SHOP DRAWING REVIEW

VT ROUTE 114 BRIDGE #13
 RETAINING WALL PLAN
BURKE, VT

DRAWN BY	DATE	JOB NO	SHEET NO.
T.J.P.	3.13.15	M915J118	R-1

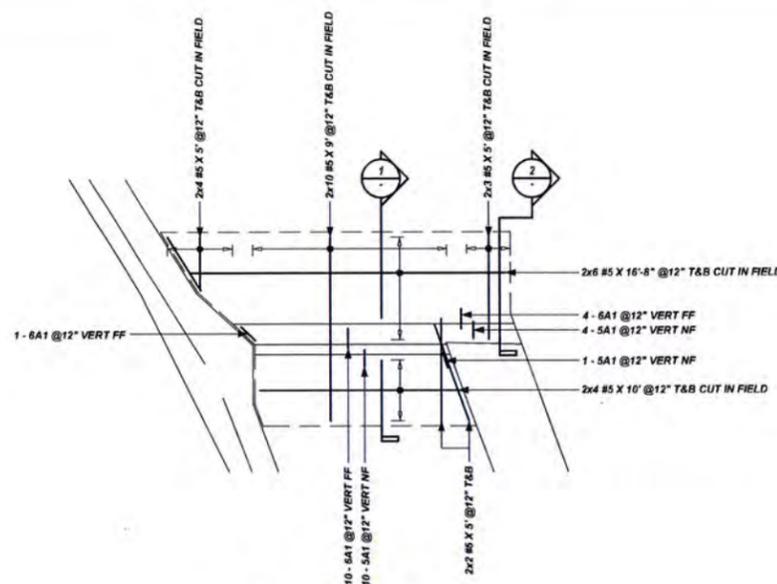
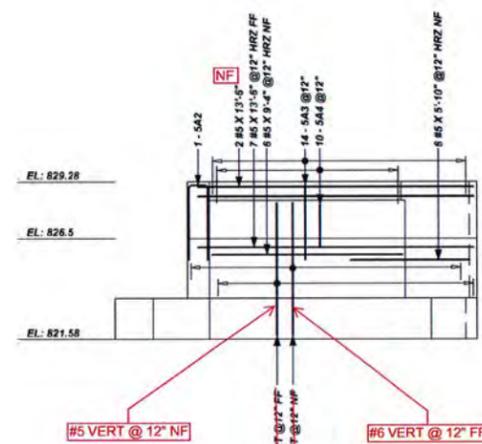
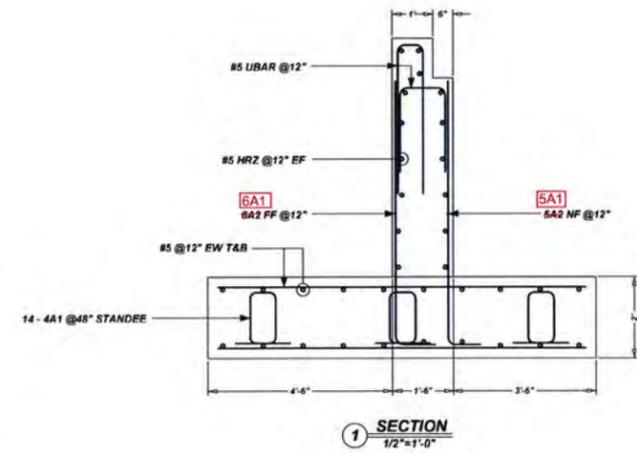
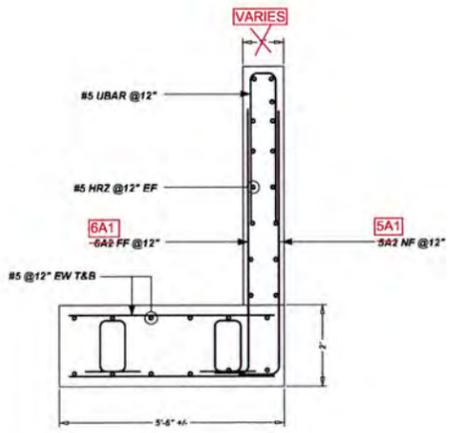
- 1. IDENTIFY REBAR TYPE - LEVEL 1 OR LEVEL II, AS APPLICABLE, ON EACH SHEET.
- 2. NEED A MATERIAL LIST FOR ALL BARS, NOT JUST BENT BARS.

DRAWN BY	DATE	JOB NO	SHEET NO.
T.J.P.	3.13.15	M915J118	R-4

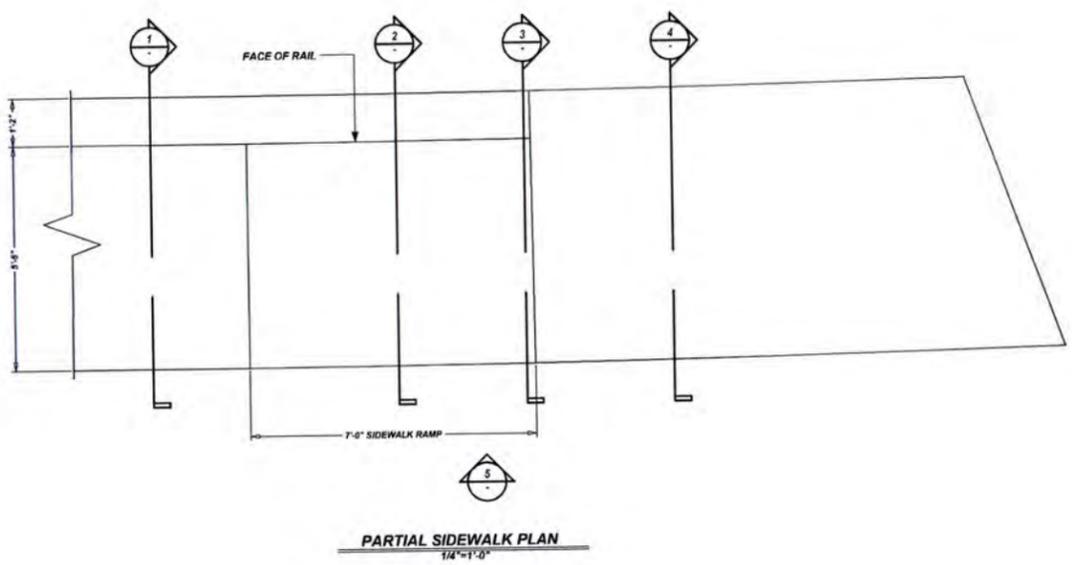
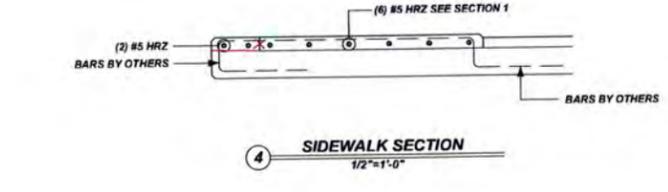
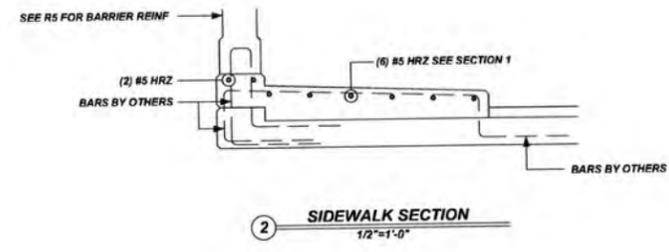
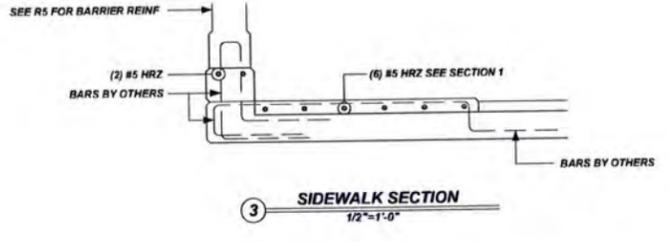
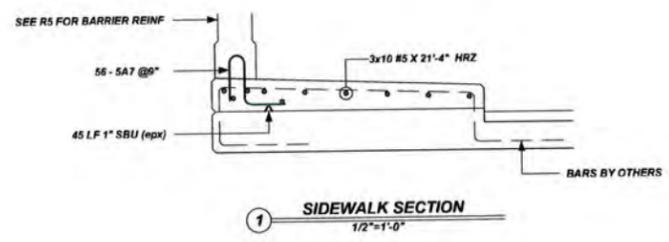
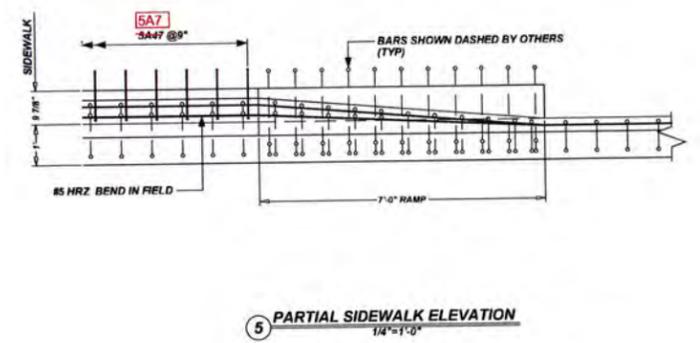
BAR S7 DOES NOT MATCH THE CONTRACT PLANS REBAR SCHEDULE. REVISE. ALSO, NO "H" IS SHOWN ON BEND S7.

RAIL ELEVATION NORTH
1/2"=1'-0"

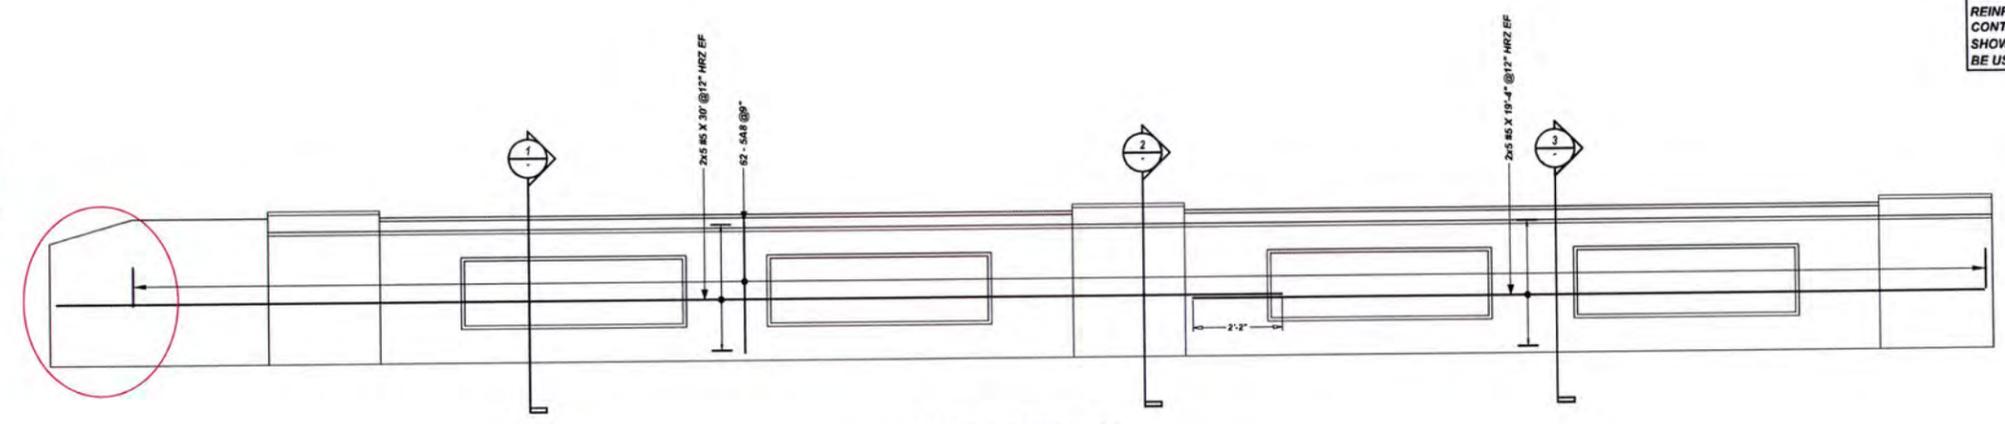
WHAT ABOUT BARS AT END OF RAIL. BARS ARE STILL NEEDED HERE. PLEASE ADD.

RAIL ELEVATION SOUTH
1/2"=1'-0"

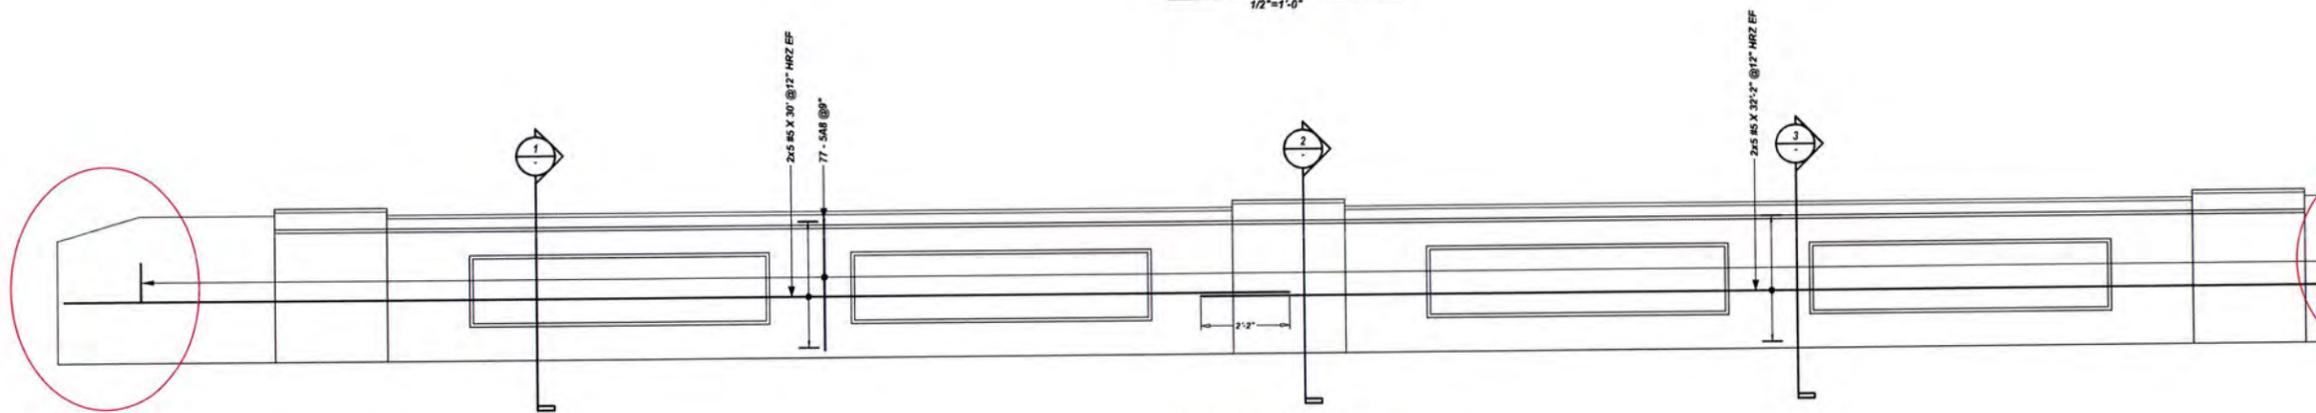
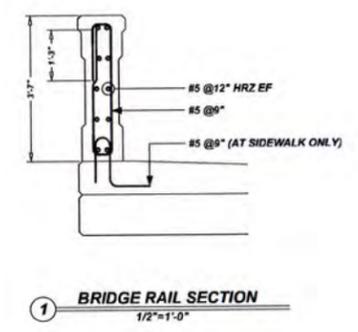
DOUBLE CHECK LENGTH
